ALPINE CITY PLANNING COMMISSION MEETING

A. Major Subdivision Preliminary Plan Review – Montdella – Alan Cottle

SUBJECT: Major Subdivision Preliminary Plan Review – Montdella

Prepared By: Austin Roy, City Planner
Planning & Zoning Department

STREET A
PP01

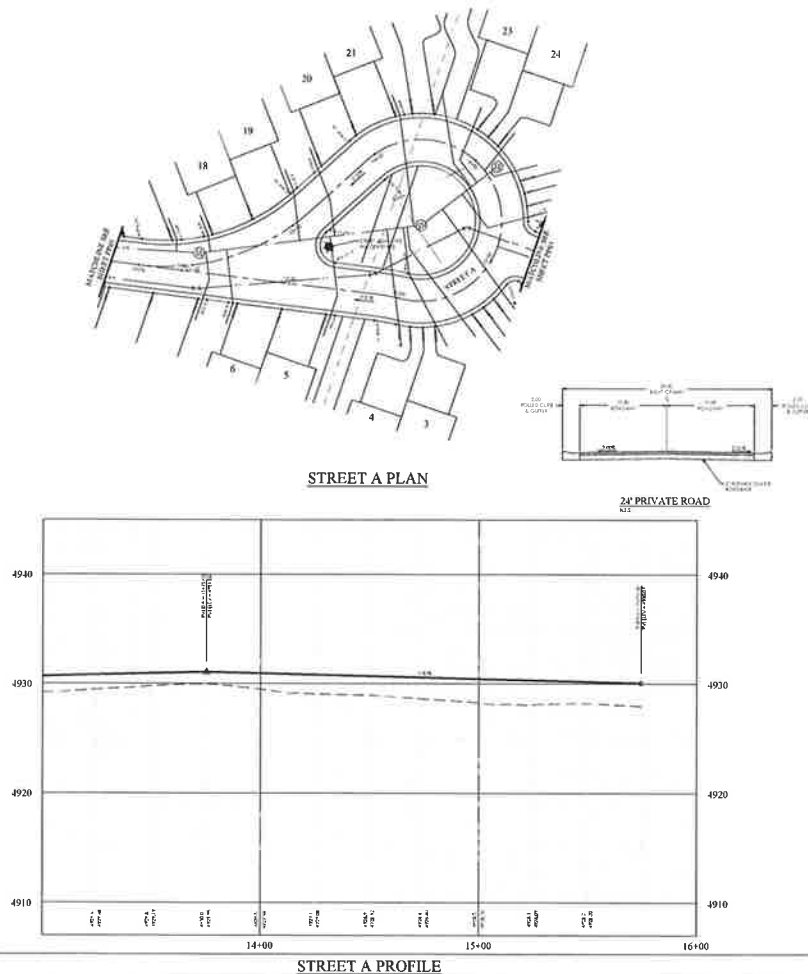
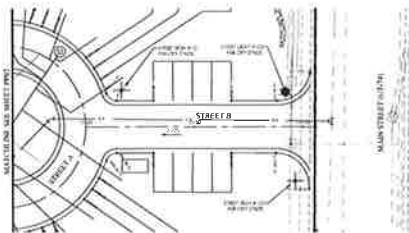
1. The road width will need to be 26' to accommodate an aerial fire apparatus. The plans show 24' including the rolled curb.
2. The round about island will need to be reduced to accommodate placement of fire apparatus in that area during a fire and address the turning radius negotiation of apparatus travel.
3. Due to the close proximity of the housing units and the risk of fire exposure spread, at least one additional fire hydrant will be required midway through the private street.
4. Based on limited access to the rear of the structures on the north side, we will likely restrict the use of barbecue grills on floor two rear patios.
